Architectural Review Board

Project name: Stonefield Block D1-1 ARB # ARB-2020-56

Architectural Review Board Application /
Certificate of Appropriateness Minor Amendments

DESCRIPTION OF AMENDED PROPOSAL

HYDRAULIC - WEST BOUND

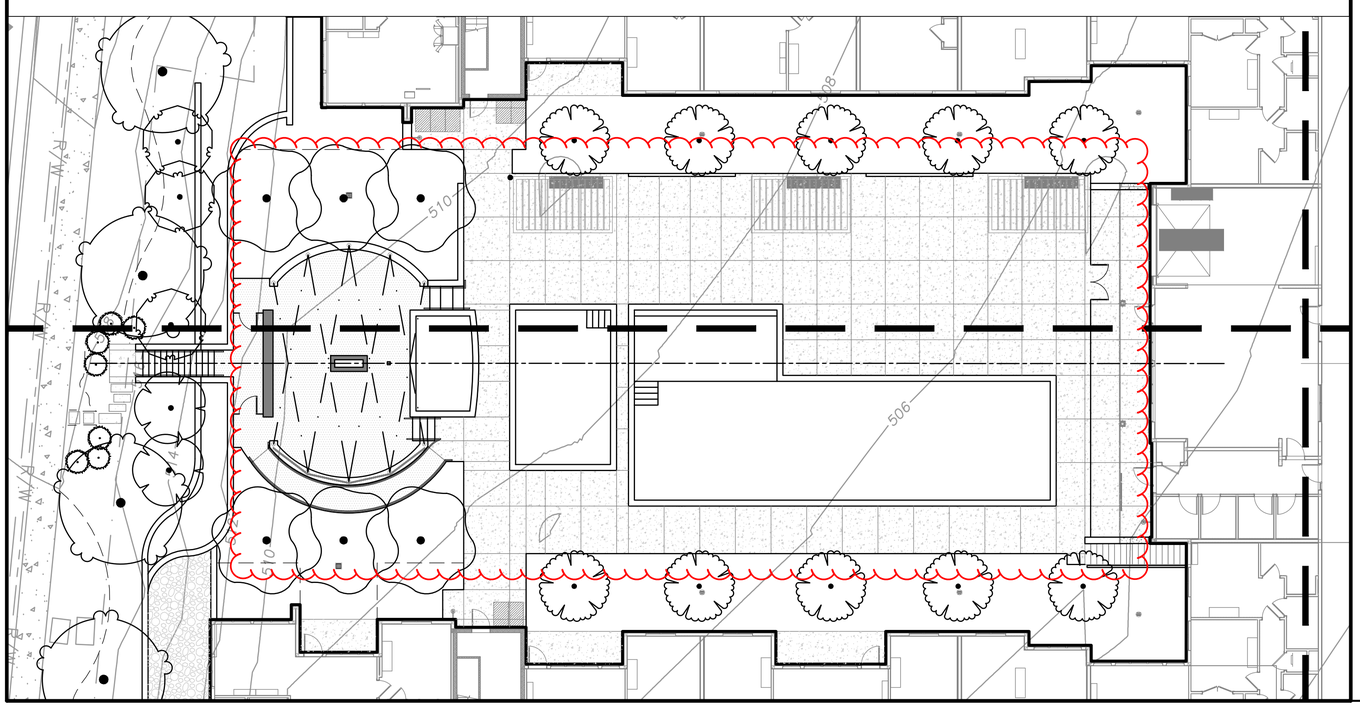
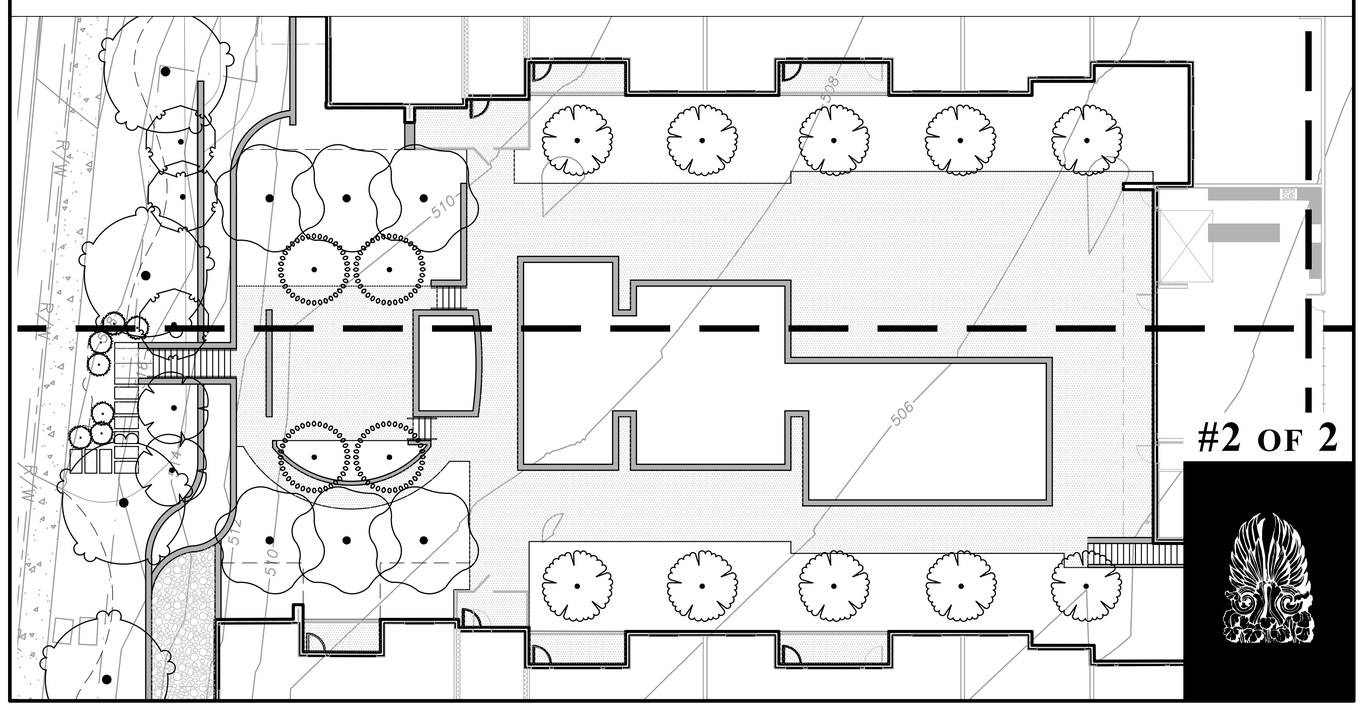
1. EXTERIOR BUILDING COLOR

Color to correspond to adjacent Shops at Stonefield, while retaining red brick; color contrast below windows in lap siding area further articulates building mass.

2. LAP SIDING W/ PANELS

James Hardie Aspyre Artisan Lap Siding (5/8" thick) no longer available; substitute HardiePlank Lap Siding (5/16"); panels under vertically stacked windows to break up the lap siding runs.

7. REMOVAL OF VERTICAL LINE OF BALCONIES

Facilitates project pro forma requirement for increase in units.

OVERALL LANDSCAPE PLAN

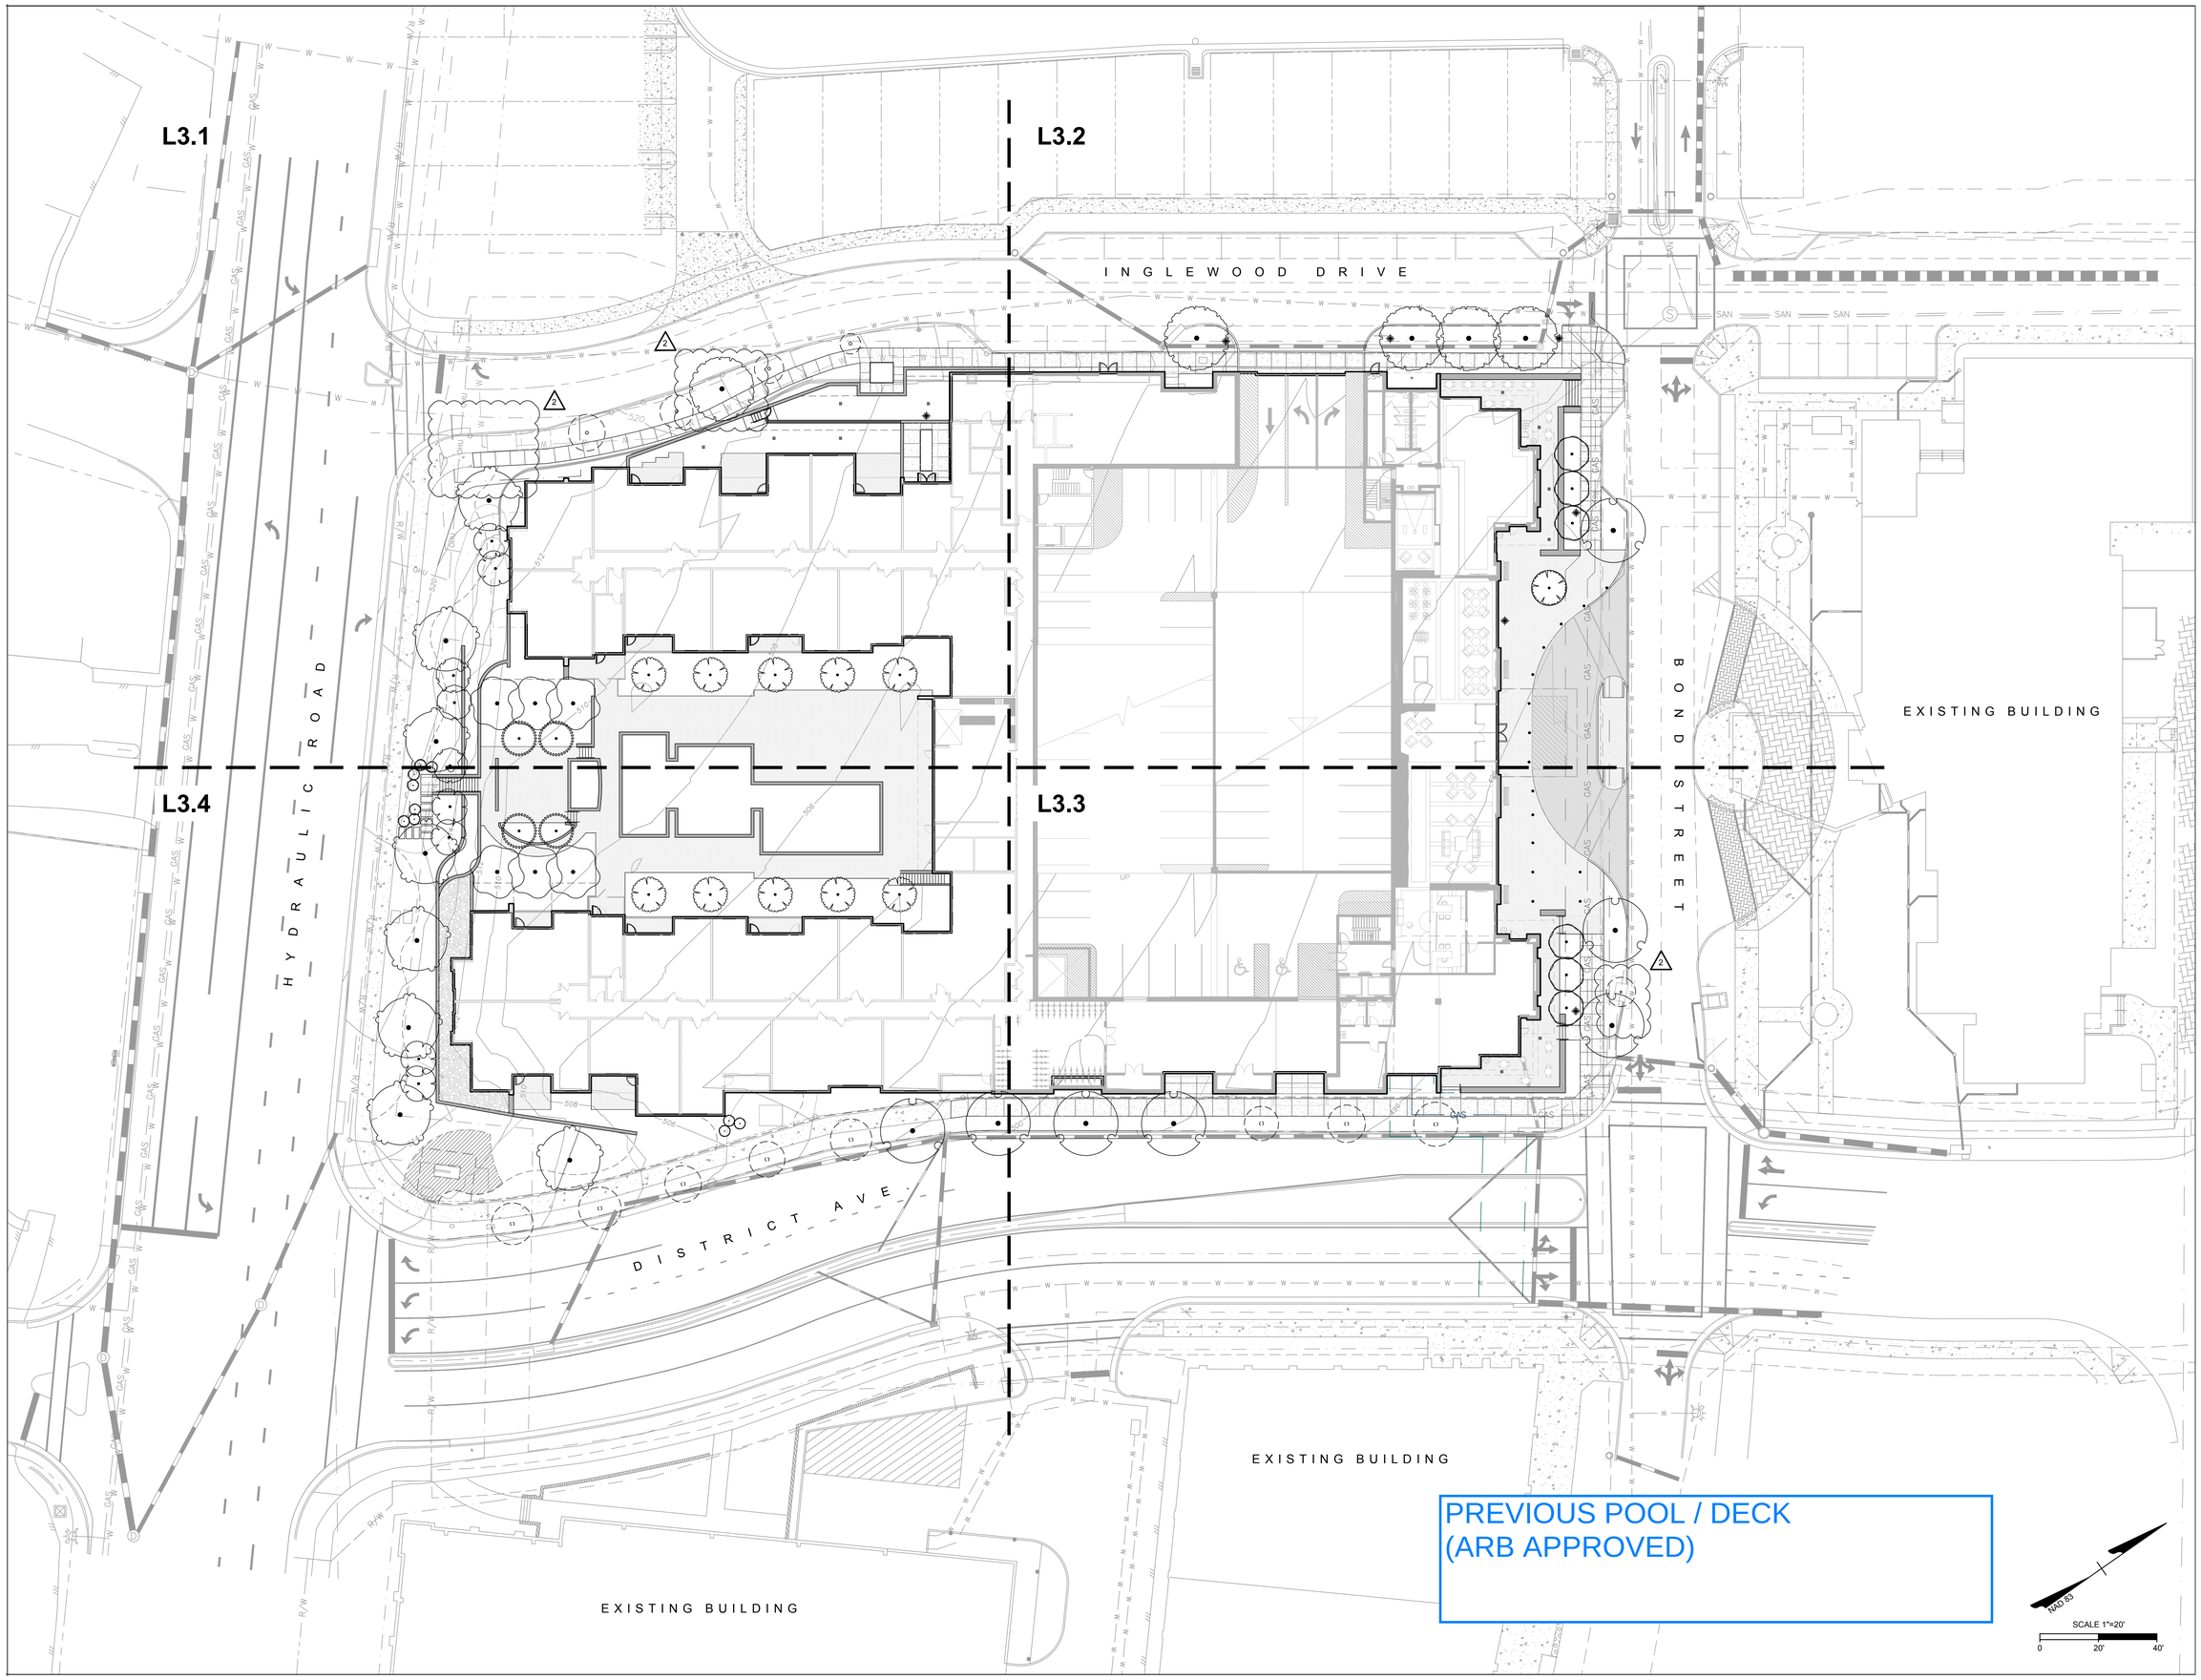
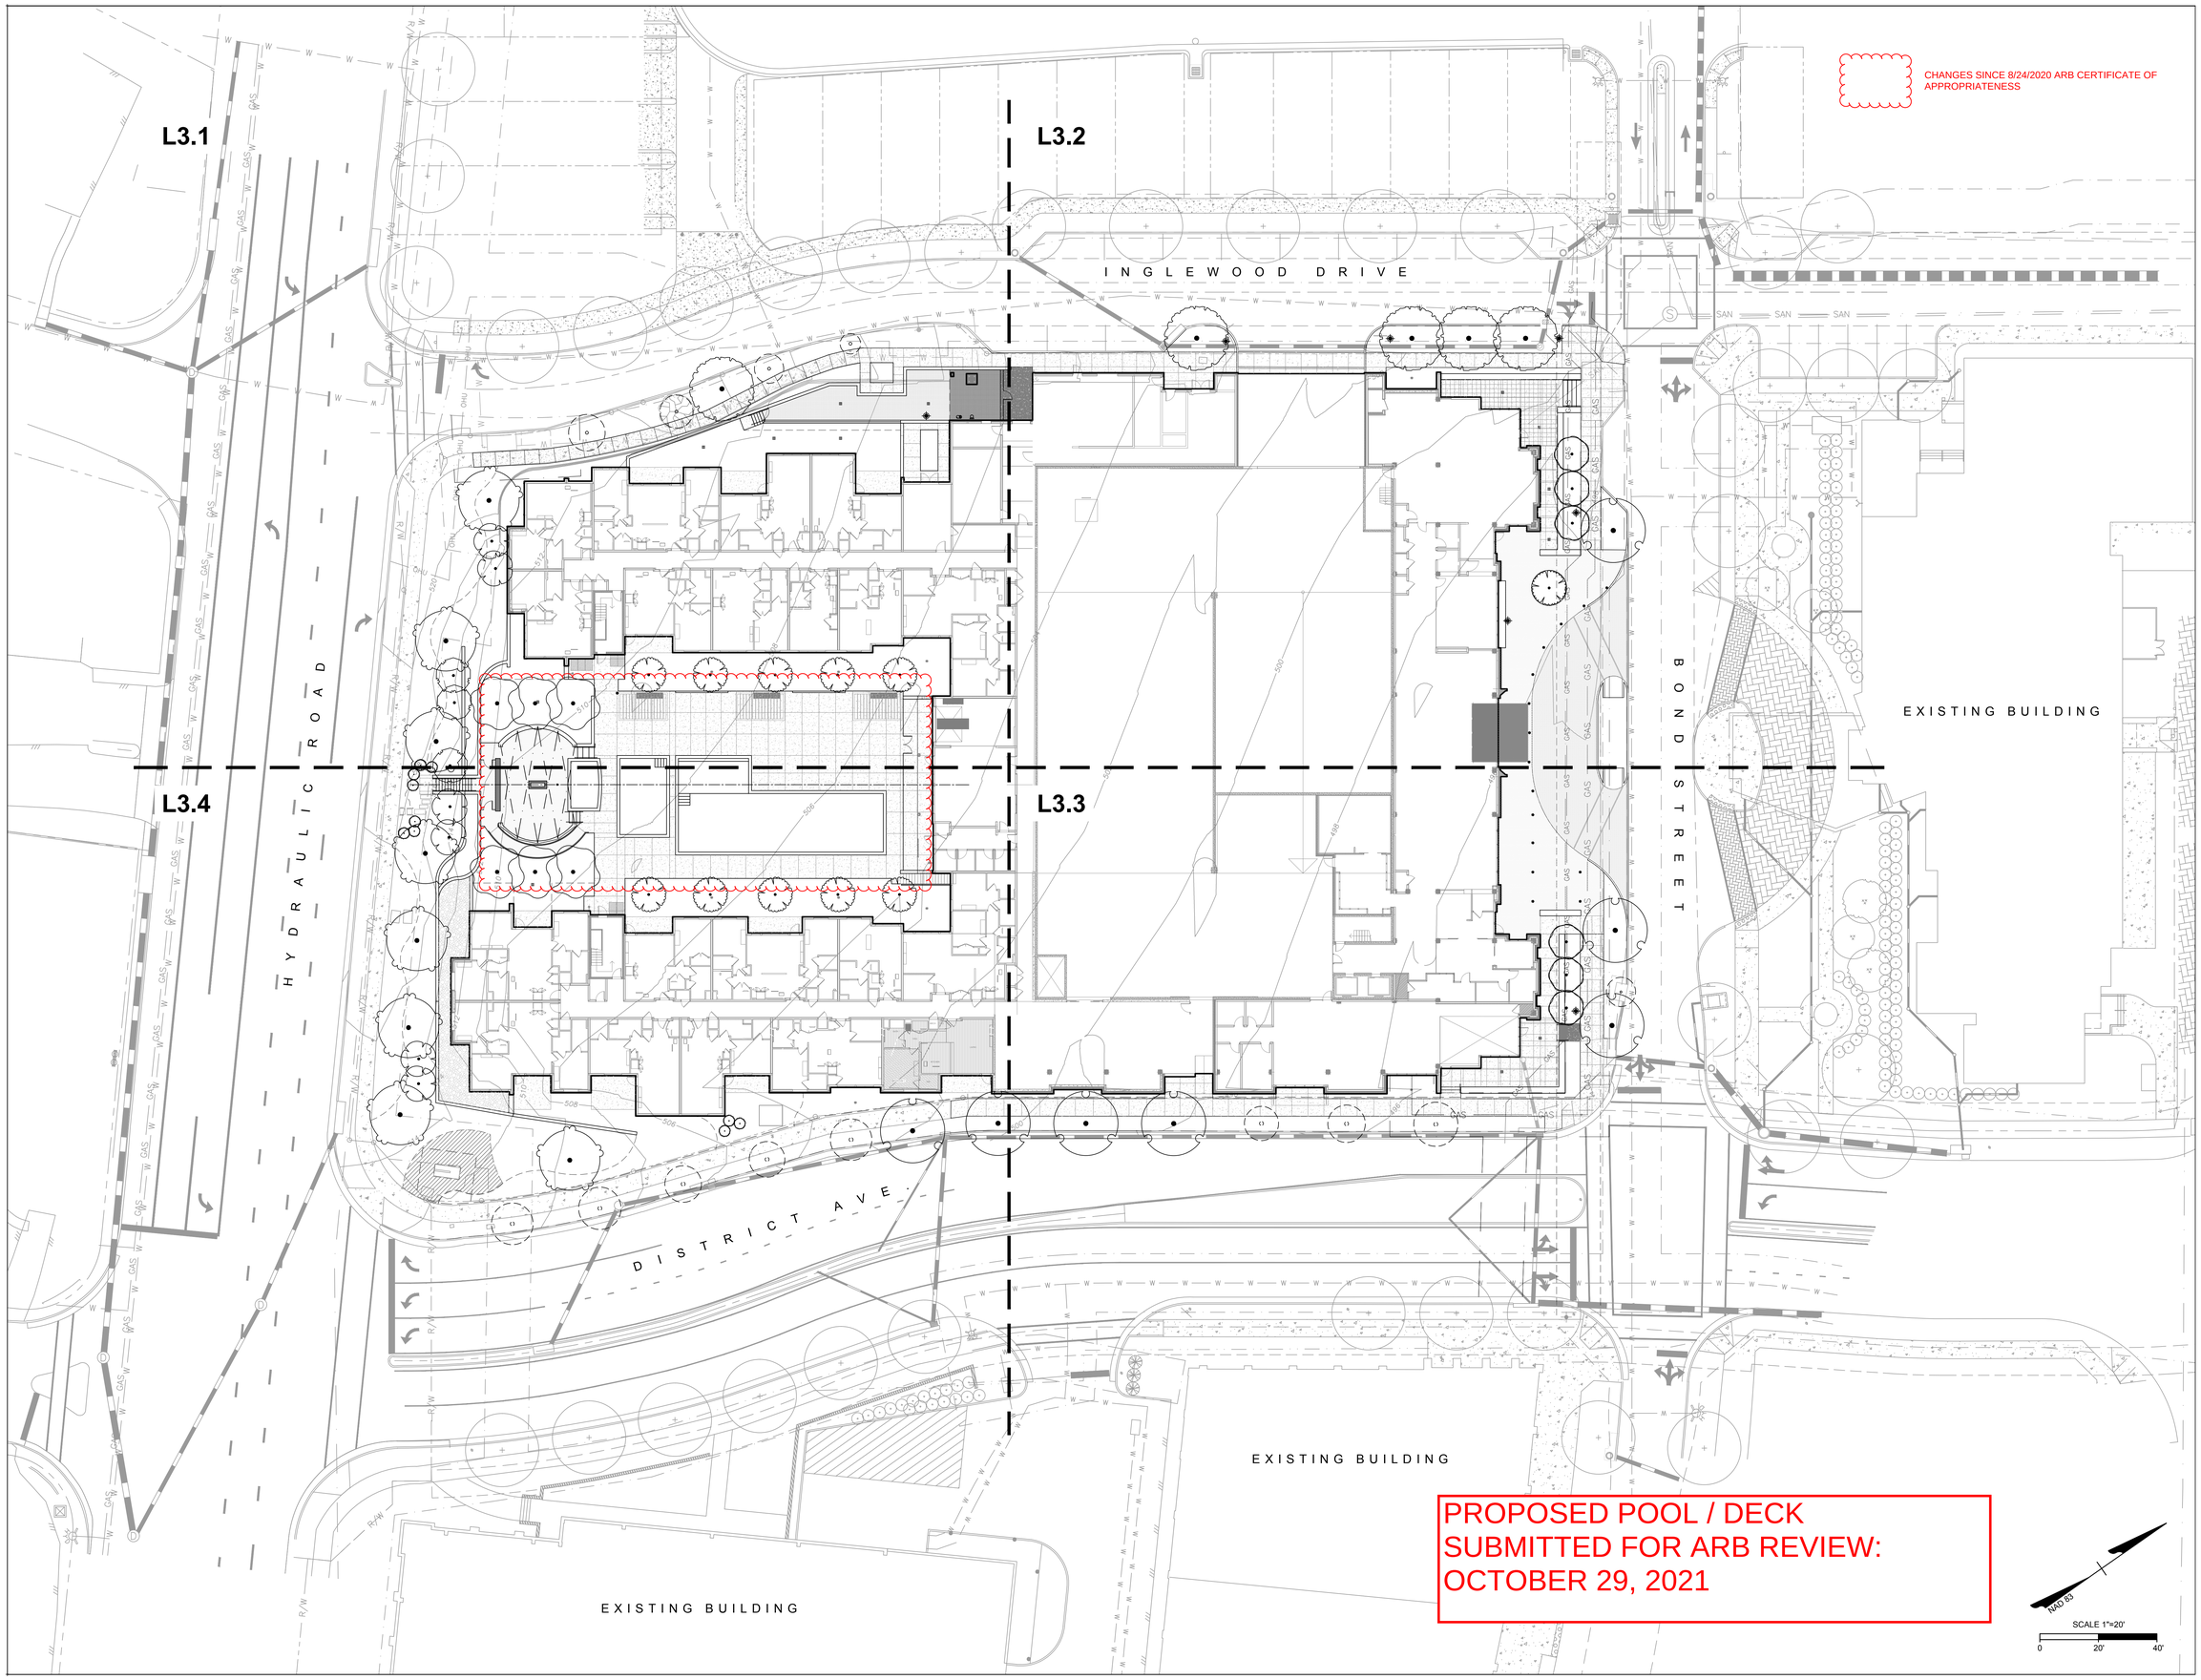
8. COURTYARD POOL & POOL DECK LAYOUT

Pool Deck, Pool shapes / sizes adjusted as design was refined.

TYPE D - PREVIOUS (ARB APPROVED), pg01

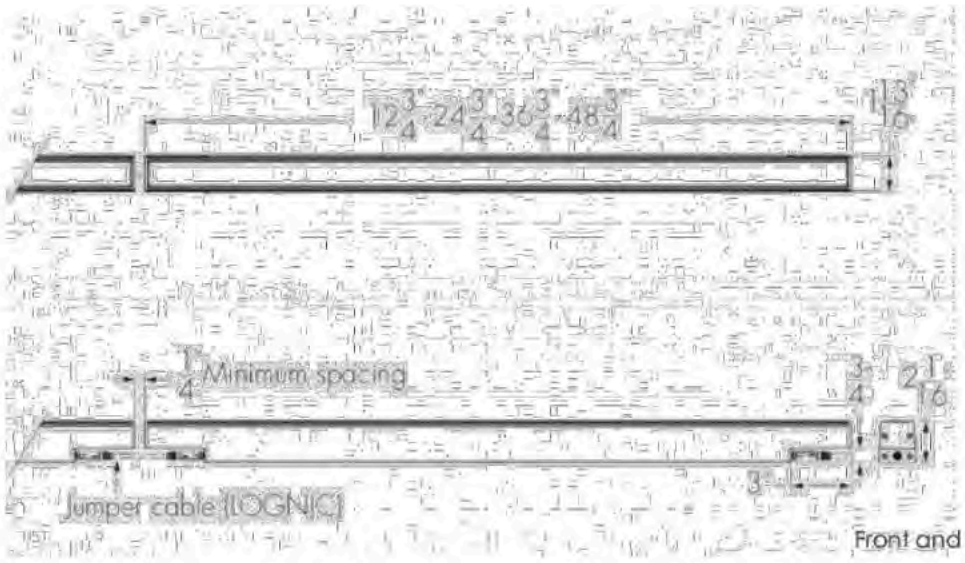
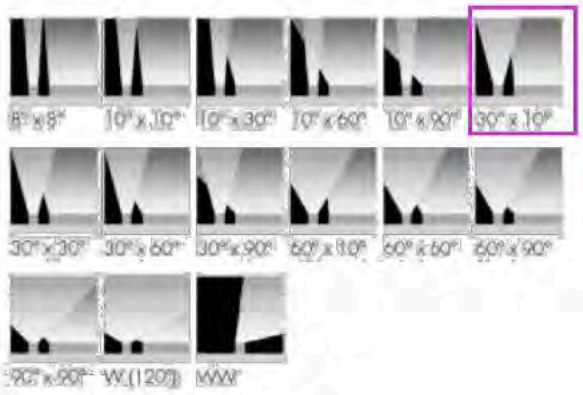
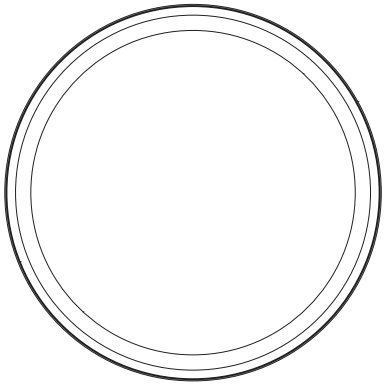
6. BALCONY LIGHTING

Fixture substitution for ceiling mounted balcony light; output @ 1000 LM (below 3000 LM threshold requiring photometrics recalculation).
